| RIGOH | Technical Bulletin | | | No. RTB-014 | | |
| SUBJECT: FINISHER ENTRAN | ICE GUIDE | | | DATE:Jan. 31, '93 PAGE: 1 of 6 | | |
| CLASSIFICATION: Action Required Troubleshooting Retrofit Information | Revision of Information Other | service manual only | MOD F410 | EL: FINISHER | | |
| It has been reported that several sorter stapler (A377) entrance guide become deformed. (This is introduced in F400/F410 RTB No.13, please refer to it for details) Since the F400 finisher has the same type of guide plate, the entrance guide plate [A] is | | | | | | |

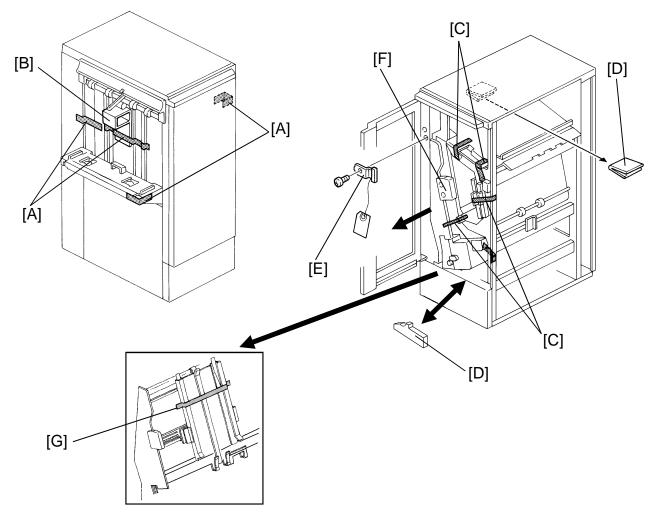
| RIGOH | Technical Bulletin | | | No. RTB-014 | | |
|--|-------------------------------|------------------------|-------------|-----------------------------------|--|--|
| separated from the finisher and kept in the accessory bag. This is implemented from the first February 1994 production machine. | | | | | | |

Whenever transporting the sorter stapler after taking out of the carton box, separate the guide plate from the finisher. Reset it just before you dock the finisher to the copier.

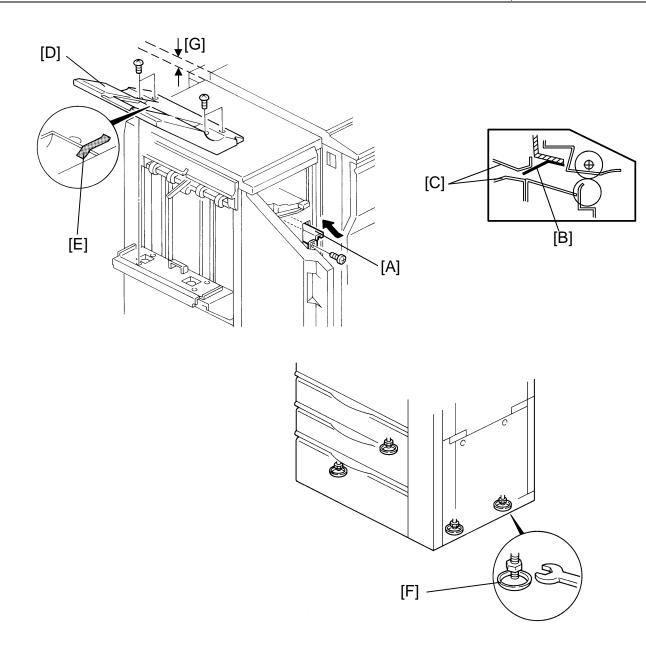
13. Install the entrance guide plate [L] (2 screws -M4 x 6).

Page 25 of Finisher Step #6

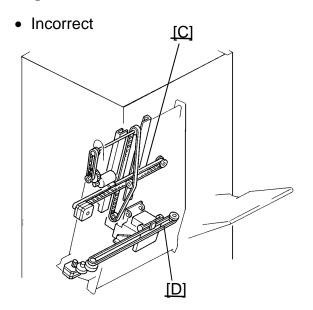
Incorrect

6. Remove the rear cover [G] (5 screws).

Correct

6. Remove the rear cover [G] (6 screws).

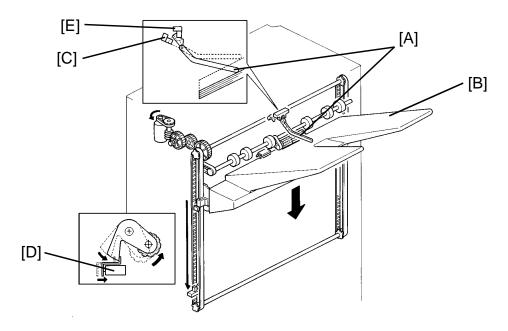
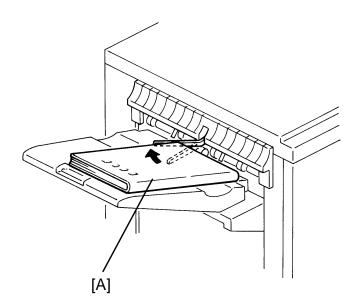
If the paper level actuator [A] is out of the position (See the illustration on page 2 of 3), the machine may sense that the shift tray [B] has not arrived at the proper level even though the shift tray [B] is at the maximum position (the stack height sensor 2 [C] is not actuated).

The fail safe mechanism (there is a safety switch [D] to detect the shift tray overrun condition) stops the shift tray lift motor from trying to raise the shift tray any more.

Under this condition, the machine indicates the "R2" jam indication. If the front door of the finisher is opened and closed and if the paper level actuator is still out of position, the machine indicates SC733.

- 1. Instruct the customer to return the actuator to the correct position (so that the actuator becomes straight) and turn off then on the main switch.
- 2. The shift tray level actuator shape has been changed so that it cannot be bent easily. This modification will be implemented from April 1994 production.
